From: Rand Ackroyd <rackroyd@comcast.net>
Sent: Wednesday, October 10, 2012 9:45 AM
To: Kerry Cramer
Cc: pdi
Subject: Re: Installation of Grease interceptors
Attachments: PDI opinion[1].doc

COMMENTS Changes to the 2012 IPC, Section 802.1.8 now requires food utensil, dishes, pots and pan sinks to be drained through an air gap or air break. There is an on-going discussion in Salt Lake County between the health department and plumbing inspectors if indirectly draining a hydro-mechanical grease interceptor to a floor sink violates the listing of the interceptor. I have read Standard PDI-G101. The testing for the interceptor drains sinks into a separation tank open to the atmosphere—similar to a floor sink. It does not appear that draining an interceptor to a floor sink would affect the operation of the interceptor.

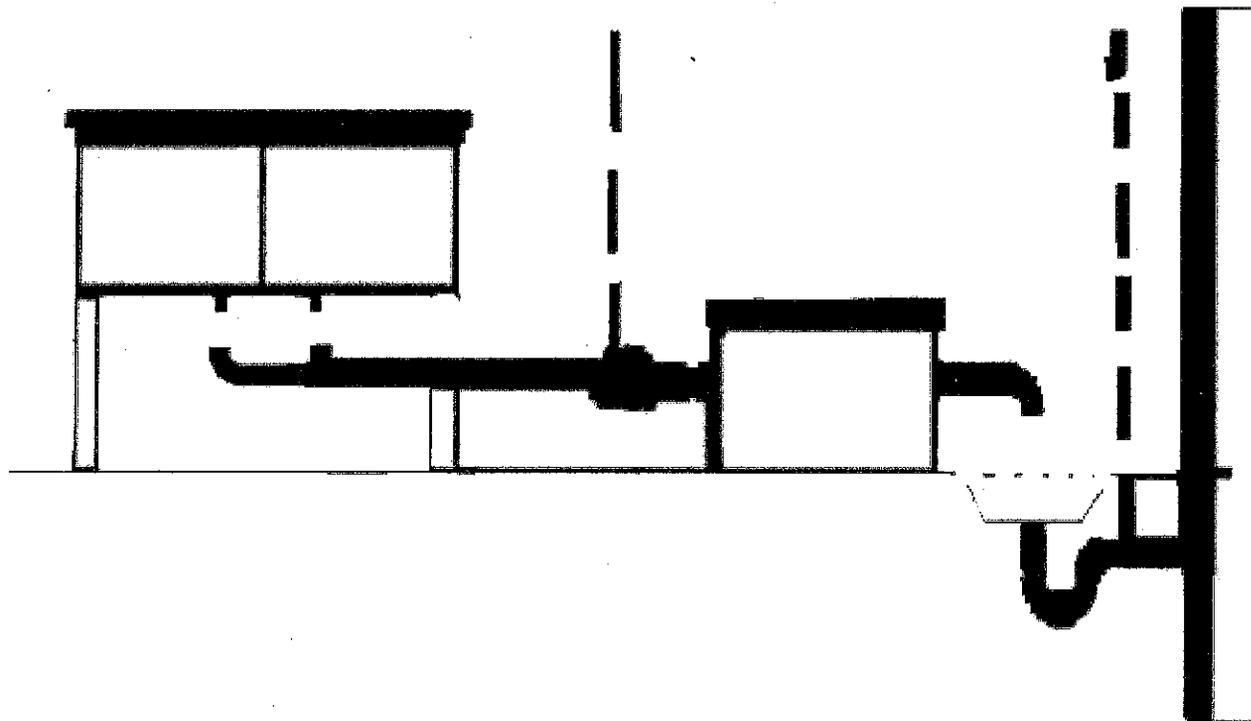
Thank you for your quick response. The diagram is accurate except that the two compartment sinks are connected to the line going into the interceptor. Some of the manufacturer's installation instructions do include the suggestion of a trap between the sinks and the flow control. As an opinion, does manufacturer's installation instructions override plumbing code requirements?

Is this the type of installation you are describing? This is similar to the installation from PDI G101 pg 25.

This type of installation with or without a direct connection to the sinks will work and does not violate an interceptors listing. This type of installation will not effect the grease removal efficiency of the interceptor. That said we need to refer to the manufactures installation instructions also. Grease interceptor although they are often called "traps" do not necessarily contain a trap feature that will provide a gas tight seal. Some manufactures do have that feature and would allow this type of installation. If a grease interceptor is cleaned regularly there is no issue but with lack of maintenance odors will escape an interceptor with out the "trap feature".
